Project 2007-12 Frequency Response

Consideration of Comments on First Draft of Frequency Response SAR

Figure 1 Original Eastern Interconnection Frequency Response Study (Ingleson and Nagle)

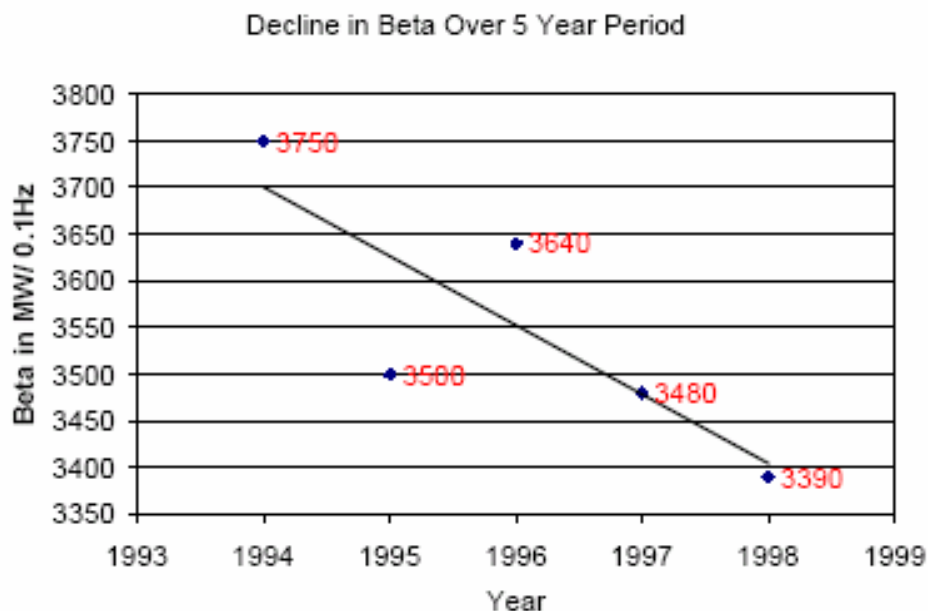
<p>Response: The Resources Subcommittee Frequency Task Force agrees that there are several issues that must be addressed in the standard or in supporting business practices. As envisioned, the proposed standard would not be prescriptive with regard to “how much” and “where” the response is carried.</p>			
<p>Manitoba Hydro (1, 3, 5, 6) Gerald Rheault</p>	<p>✓</p>		<p>Manitoba Hydro , from a reliability perspective, supports the idea of specifying the quantity and quality of frequency response and incorporating these elements in a Standard. However, the development of this standard should not be rushed since the evidence provided in the Standard Authorization Request form and in the Frequency Response Standard White paper shows that current frequency response and projected frequency response trends do not pose a significant potential for compromising system reliability and for major under-frequency load shedding to occur in the near term.</p> <p>Also in the section of the white paper which examines “frequency response standard considerations”, a broad scope and outline is given, more detail is required especially regarding methods of ensuring compliance.</p> <p>In paragraph 2, page 9 of the white paper where the current frequency response of the Eastern Interconnection is stated as 3100 MW/0.1 Hz with a standard deviation of 1870 MW/0.1 Hz and the statement is made that “the fact that an under-frequency</p>

Commenter	Yes	No	Comment
			<p>event has not happened yet is only coincidence” requires much more detailed information regarding the origin and calculations of these numbers before these assumptions can be made. Could it be that instead of a frequency response closer to 1230MW/ 0.1 Hz it is actually practically closer to 3100 MW/ 0.1 Hz or even 4970 MW/ 0.1 Hz most of the time?</p> <p>One understandable major concern addressed in the white paper is the response of combined-cycle units to frequency decline and the fact that due to a drop in combustion air volume their output may actually decrease with a drop in frequency or even result in unit tripping. Also there was concern with the possibility that larger amounts of these types of units will be installed on the system thereby potentially increasing the decline in frequency response rate from 70 MW/ 0.1 Hz /Year (Eastern Interconnection) .</p> <p>It is also mentioned (on page 10) that with proper tuning combined cycle units can provide correct frequency response. Maybe part of the focus should be on finding ways of enforcing the Current Requirements (Page 14) and including specific frequency response requirements for combined-cycle units.</p>

<p>Response: The Resources Subcommittee Frequency Task Force agrees that the standard should not rush to a decision on the amount and location of frequency response, but should set the framework for making informed decisions. Frequency response is needed for more than protection against UFLS. Response is also needed during disturbances and restoration. With regard to “current requirements”, the Whitepaper listed what existed in NERC Policy, mostly as guides. There is very little in the V0 Standards regarding governors or frequency response. We agree that the standard should not impose unreasonable costs to demonstrate compliance. We agree that frequency response should be monitored both at the BA and Interconnection level.</p> <p>Characterizing how frequency response changes under varying interconnection load and unit commitment conditions will be addressed by a sampling methodology.</p> <p>The drafting team is pursuing the addition of functionality in the “NERC –ACE monitoring application” that will identify generator trips and automate the calculation of Interconnection frequency response. Evidence to date indicates that frequency response declines significantly during light load periods, even though the exact mechanism for this is not well defined. Most of the major frequency excursions experienced in the Eastern Interconnection have occurred during the shoulder period of the year during either the early morning or late evening periods.</p> <p>Regarding the last comment, there currently are no governor or frequency response requirements for generators.</p>
